**City of Ramsey**  
**Agenda**  
**Environmental Policy Board (EPB)**

Review Natural Resources Aspects of Hampton Townhomes Preliminary Plat

<b>DATE</b>	MAY 12, 2020	<b>PROJECT ADDRESS</b>	TBD
<b>PROJECT. TITLE</b>	HAMPTON HOMES		
<b>ESCROW #</b>	117171		
<b>DEPARTMENT:</b>	Planning Division (Landscape Plan & Environmental Resources)		
<b>TECHNICAL REVIEWER:</b>	Name: Chris Anderson Phone: 763-433-9817 Email: <a href="mailto:canderson@cityoframsey.com">canderson@cityoframsey.com</a>

<b>DATE</b>	MAY 12, 2020	<b>PROJECT ADDRESS</b>	TBD
<b>PROJECT. TITLE</b>	GARDEN VIEW VILLAS		
<b>ESCROW #</b>	117177		
<b>DEPARTMENT:</b>	Planning Division (Landscape Plan & Environmental Resources)		
<b>TECHNICAL REVIEWER:</b>	Name: Chris Anderson Phone: 763-433-9817 Email: <a href="mailto:canderson@cityoframsey.com">canderson@cityoframsey.com</a>

SHEET NUMBER  
**C1.1**

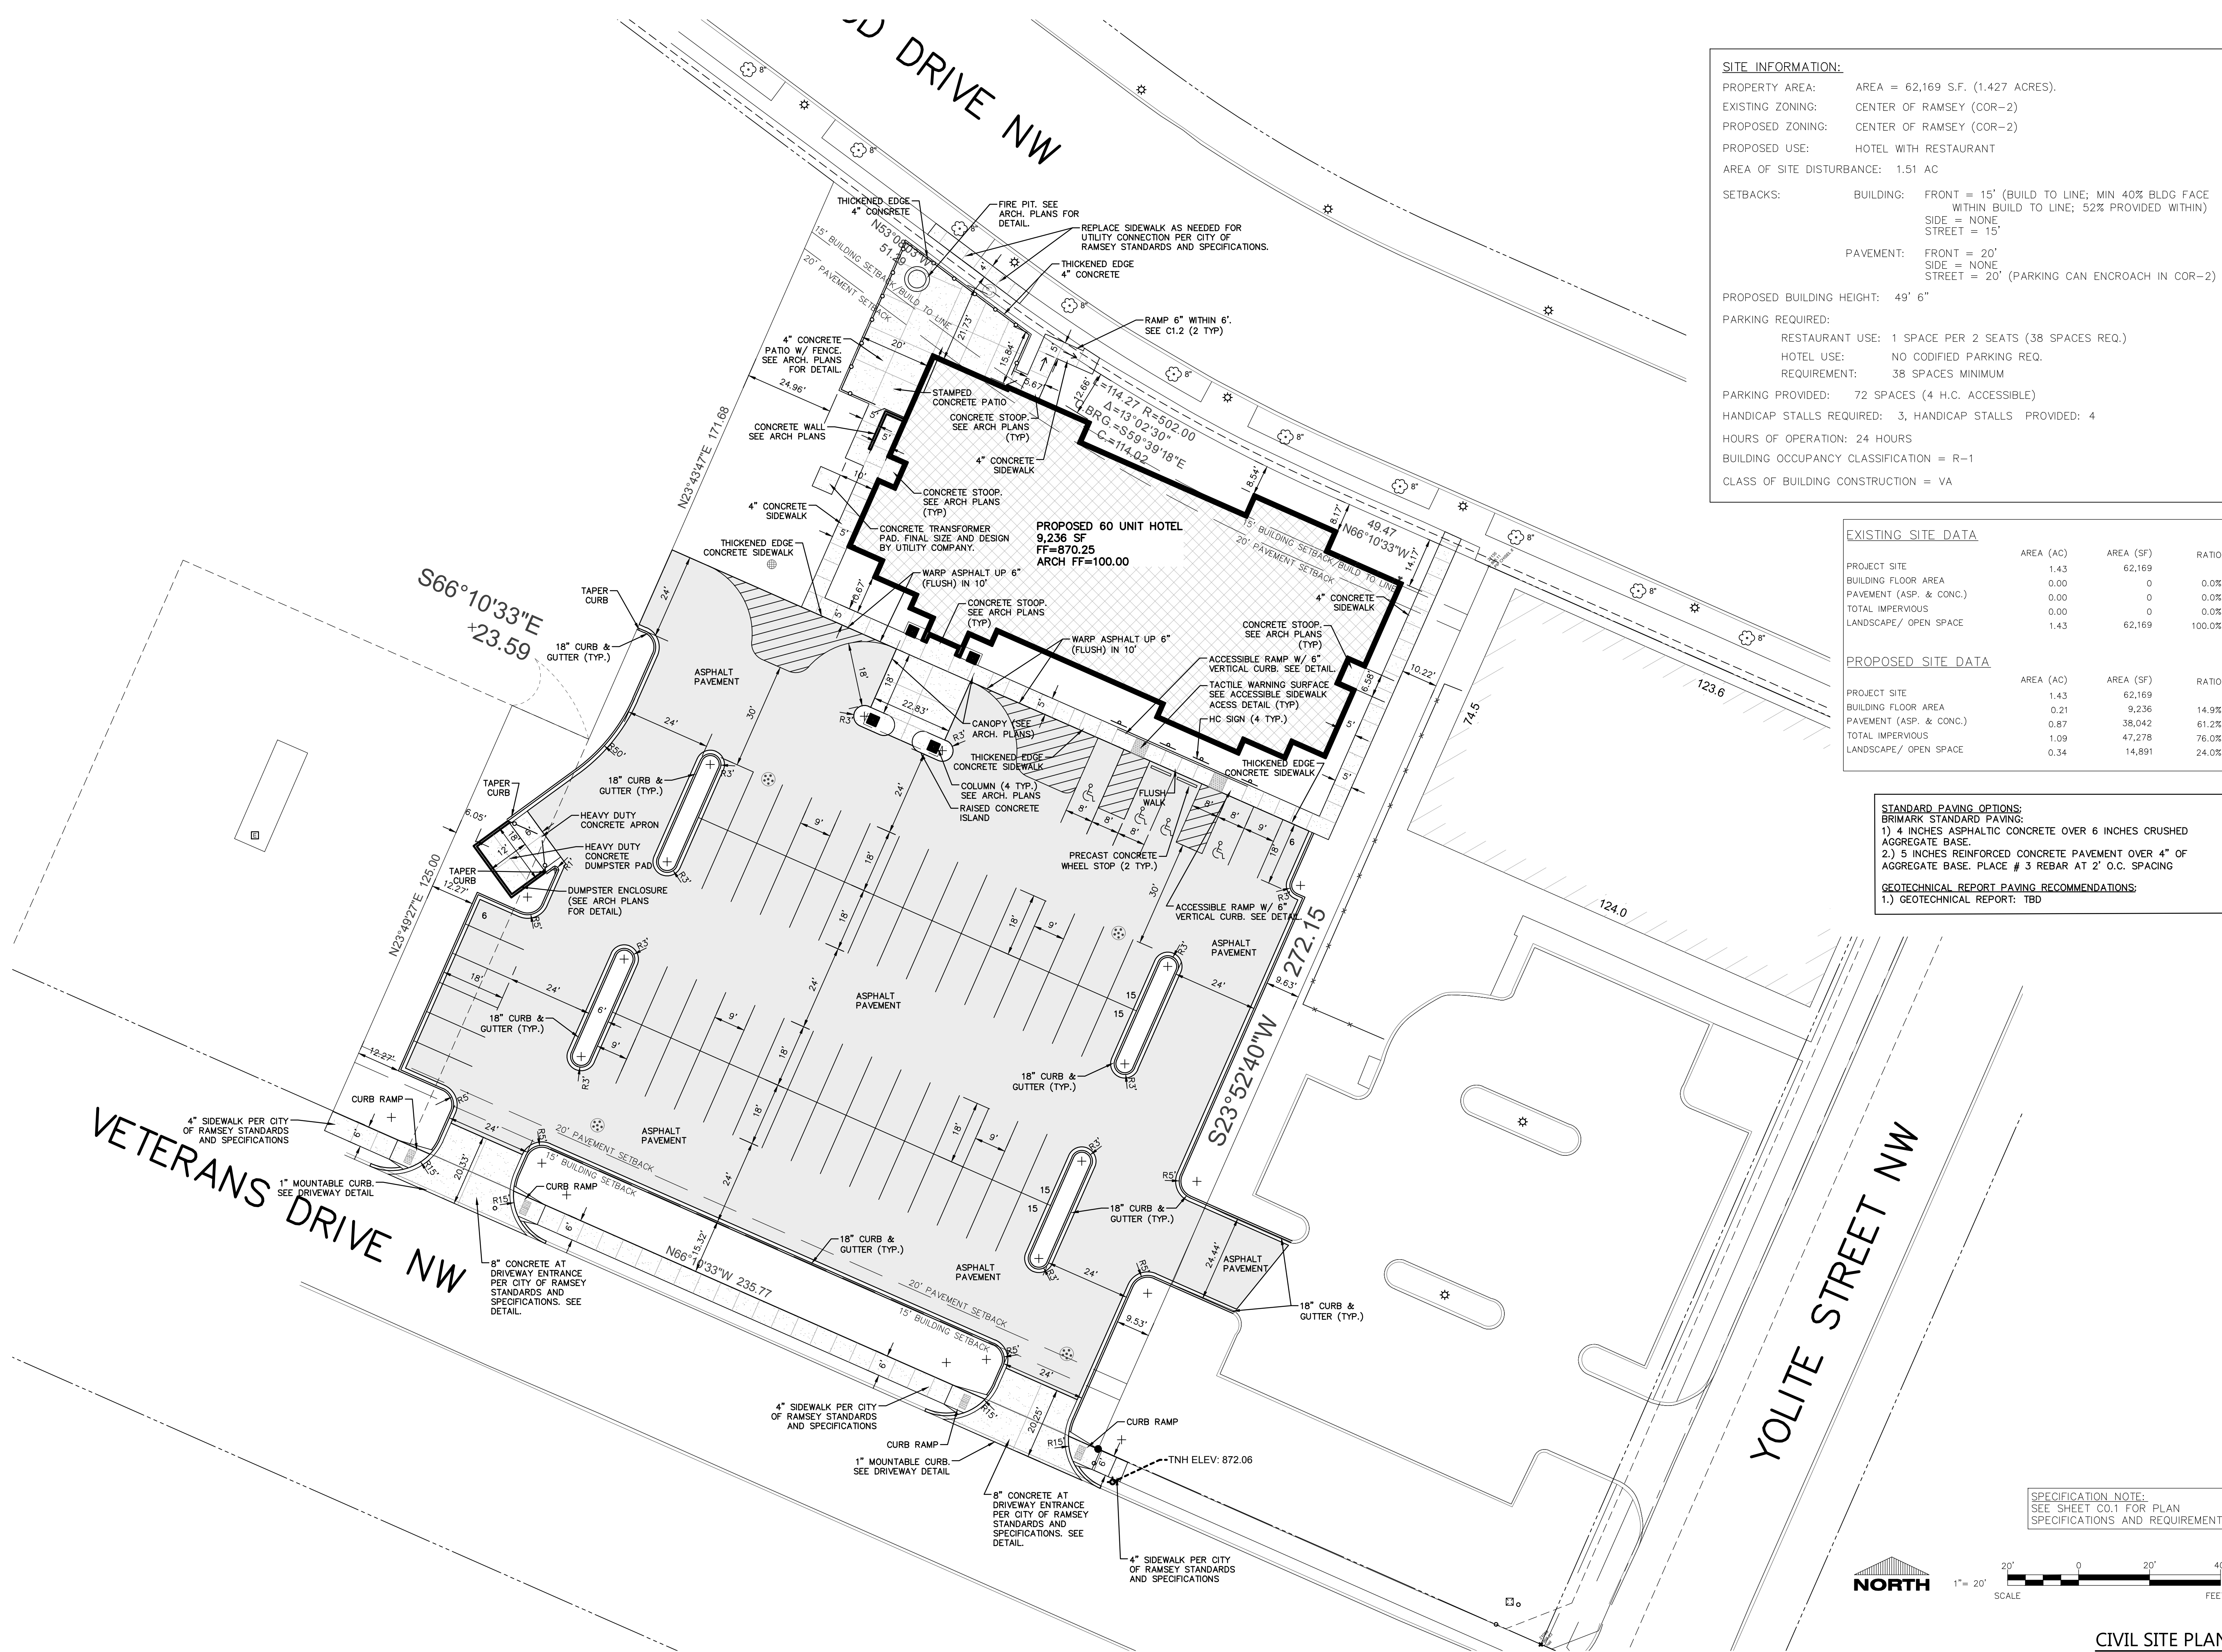
- Adequate protection and care must be taken to protect existing boulevard trees and planter beds along Sunwood Drive throughout the construction process.
